TENNESSEE VALLEY AUTHORITY

KINGSTON FOSSIL PLANT

ANNUAL ASH POND DIKE
STABILITY INSPECTION
2009

Prepared by: Chris Buttram
Date: January 12, 2009

Fig. 3 Discharge to Stilling Pool

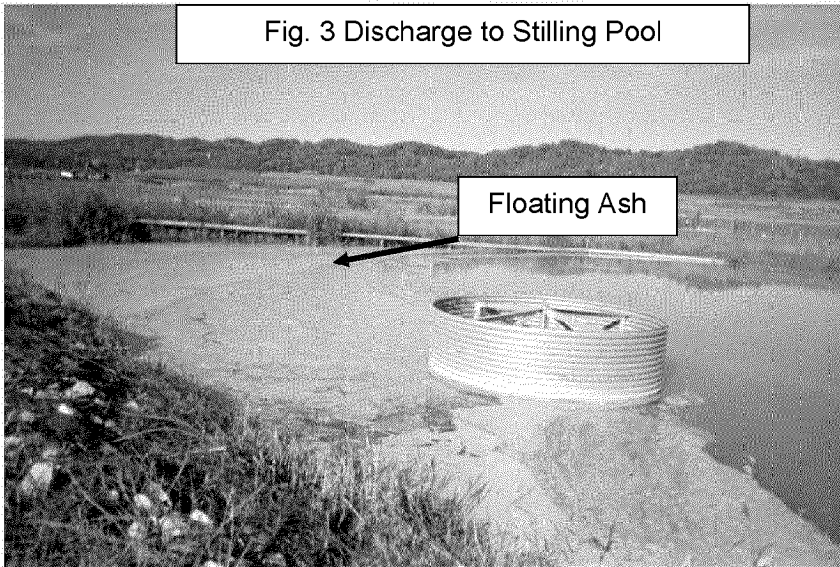
Floating ash near discharge structures, as seen in Figure 3 below, should be removed to prevent an accidental release. Check the floating skimmer booms and maintain them to keep floating ash away. The seeps on the bench of Dike "C" north of the intake skimmer, mentioned on previous reports, have not been observed since wheel ruts were repaired a few years ago. No seeps or wet spots were seen in this area during the inspection.

Fig. 4 Typical Erosion on Road

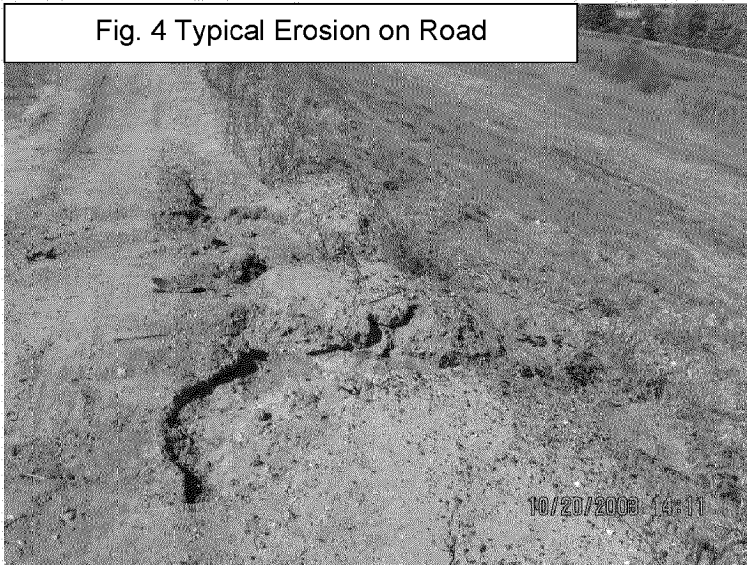
Some of the dike roads exhibit areas of erosion on the edges and some rutting, see Figure 4. This photo is typical of the eroded areas of the roads. Although it does not appear to be a significant problem, these eroded areas, as well as any ruts, should be graded out and the road covered with crushed stone to prevent larger erosion gullies.

Fig. 5 Ash Pond Internal Dike

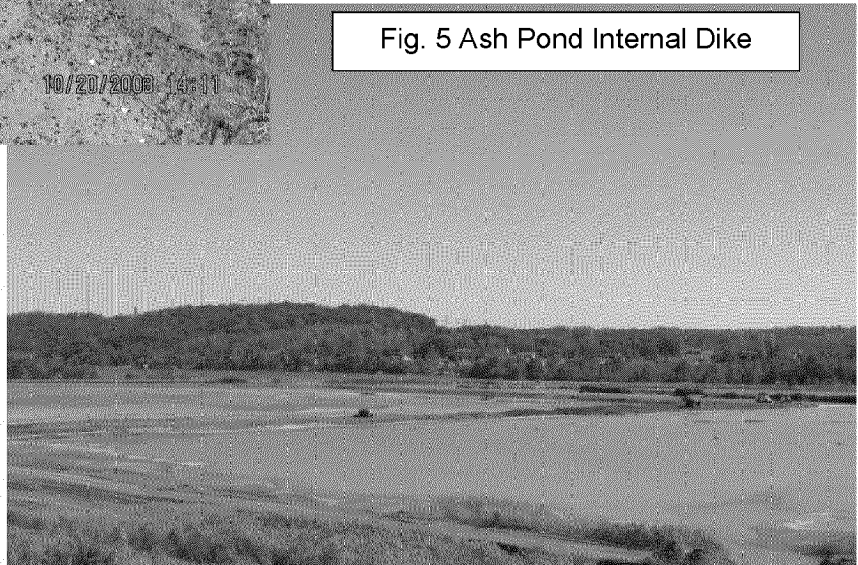
to two feet above elevation 760, the elevation of the water in the pond. The divider dike will be constructed to build a base of fly ash for a dredge cell expansion, which will eventually cover approximately half of the existing main ash pond. See Figure 5.

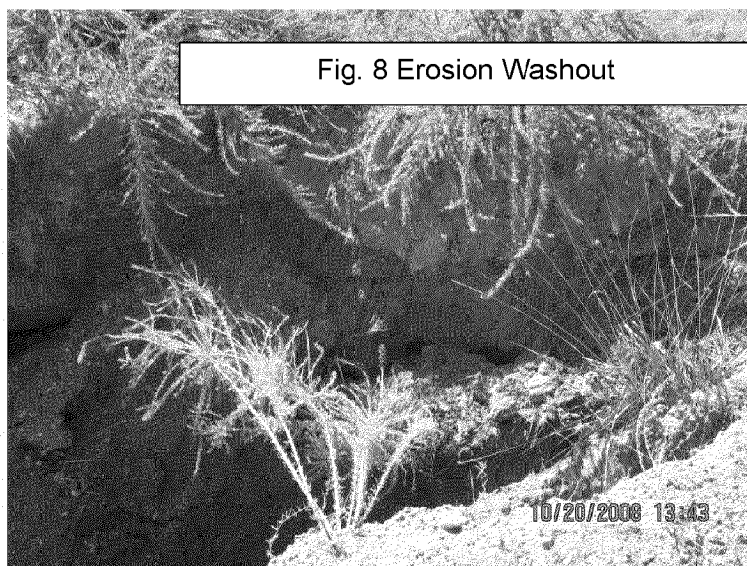
drainage should be graded so they will drain, even if slowly. Also, thick vegetation in drainage ditches (Fig. 6) should be thinned out or removed to keep from blocking the water flow. Wheel ruts on benches or in roads that are holding water should be filled with bottom ash and covered with stone.

Fig. 12 & 13 Washout on dike bench

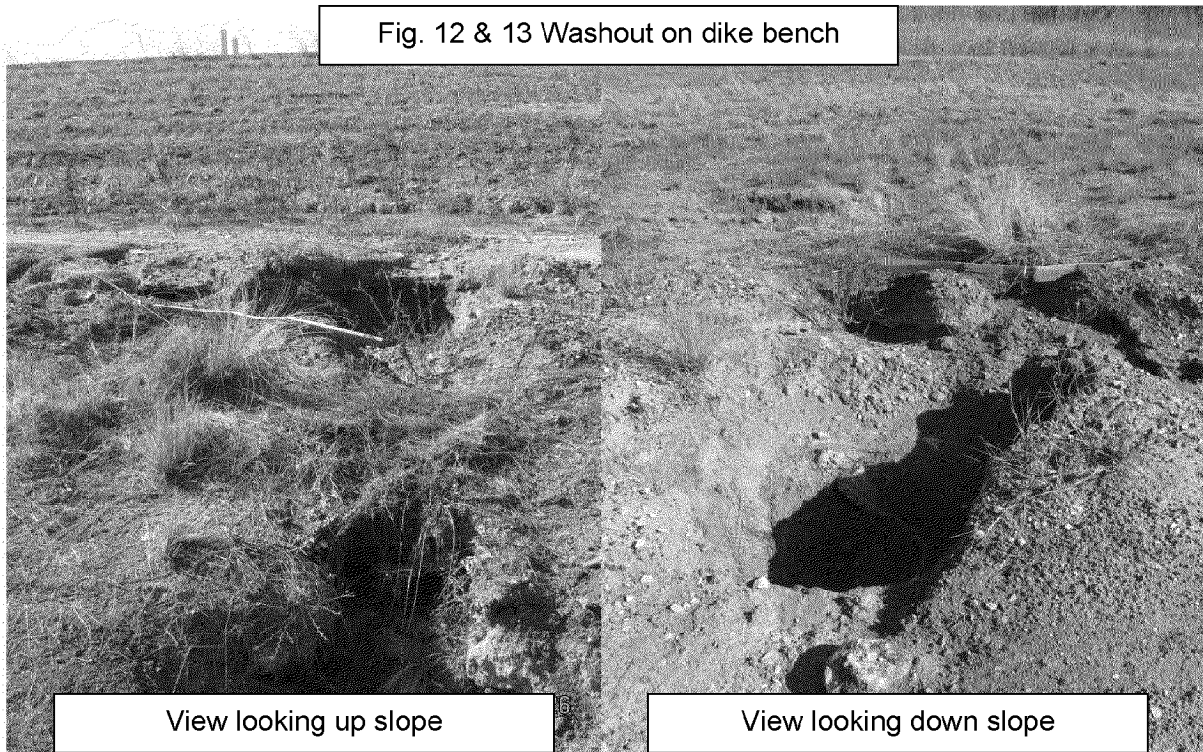
Due to extensive erosion in one area, a washout two feet wide by twenty feet long by two feet deep had formed (Fig. 8). This area should be repaired by filling bottom layer with six inch lifts of compacted bottom ash until clay area is reached. Cap with one foot of clay using six inch compacted lifts. It is recommended that an erosion control blanket be used in this area for quicker vegetation growth. Monitor this area, especially after rain events, to assure that no settling occurs.

- Repair broken dewatering well outlet pipes. These pipes should be draining directly into the lined ditch at the bottom of the cells.
- Repair the 2' x 20' area of erosion on the east slope of the interim dredge cell. Fill bottom layer with bottom ash in 6" lifts and compact. When the clay layer is reached, cap with 1' of clay via 6" compacted lifts. Lastly, cover with an erosion control blanket to help stabilize the damaged area. After repairs have been made, continue to monitor area until good vegetation has stabilized the area.
- Repair erosion washout on lower dike bench at North end of dredge cells. Repair eroded area by filling with clay in 6" lifts and compacting, then reseed and fertilize per T-1, section 580.
- Continue to monitor the wet spot at the toe of the Cell 2 dike.

Fig. 16 Check Dams needing repair

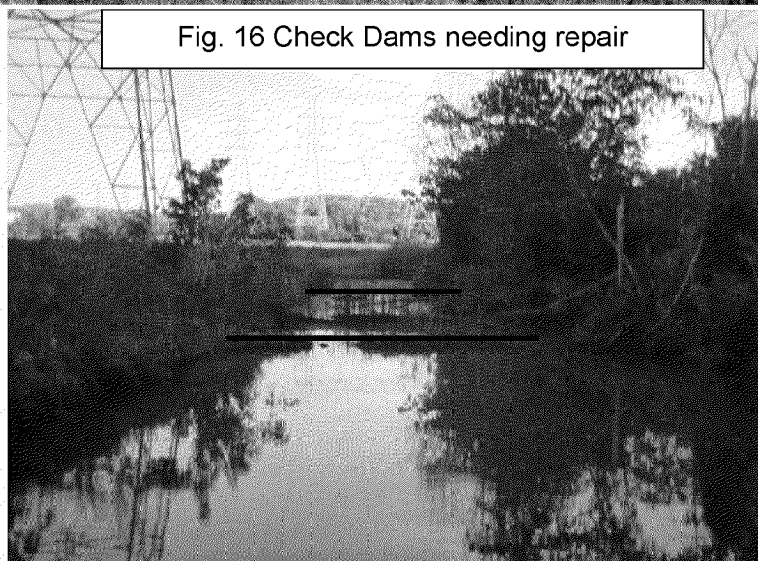
contain coal yard sediment. Figure 16 shows rock check dams built to keep the coal fines away from the pumps. The check dams appear to be in need of repair and cleaning out. If maintained properly, the check dams will keep sediment from reaching the pumps. TVA drawing 10W225-1 (attached as API 2009-2) shows the pond and its intended bottom contours. The coal yard drainage basin should be cleaned out annually.

- Dredge the coal yard drainage basin to restore its design contours and protect the pumps from further damage. There is an estimated 2,800 cubic yards of sediment in the original pond and an extra 3,400 cubic yards in the "V" section that needs to be removed as soon as reasonable. See the attached copy of 10W225-2.
- Repair and clean out riprap check dams in the coal yard drainage basin to keep solids away from the pumps.

Fig. 23 Dewatering well overflowing redwater

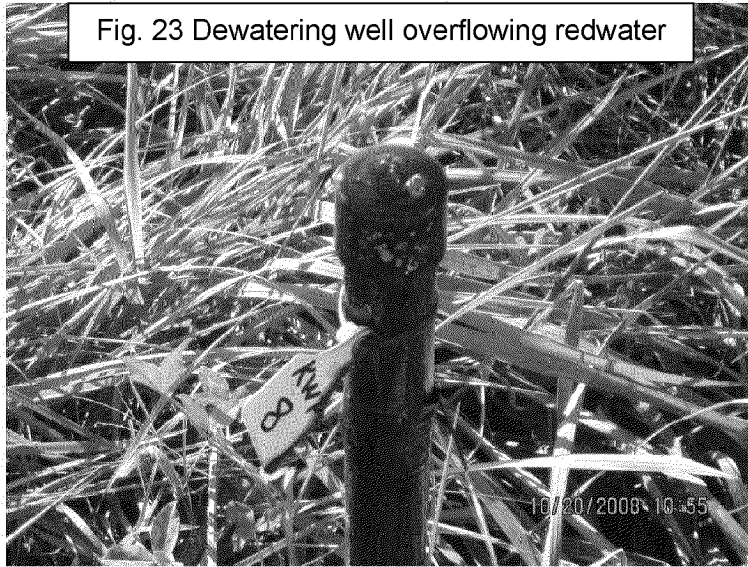
Besides the wetlands, there was only one spot that showed flowing redwater. When dissolved iron from the ash and water mix, it tends to give the water a red appearance. This area was first thought to be a seep, but it was discovered that the redwater was flowing out of a dewatering well that had a closed valve. The water was flowing down the slope into the riprap ditch. The riprap ditch was also stained some at the outlet area for this dewatering well.
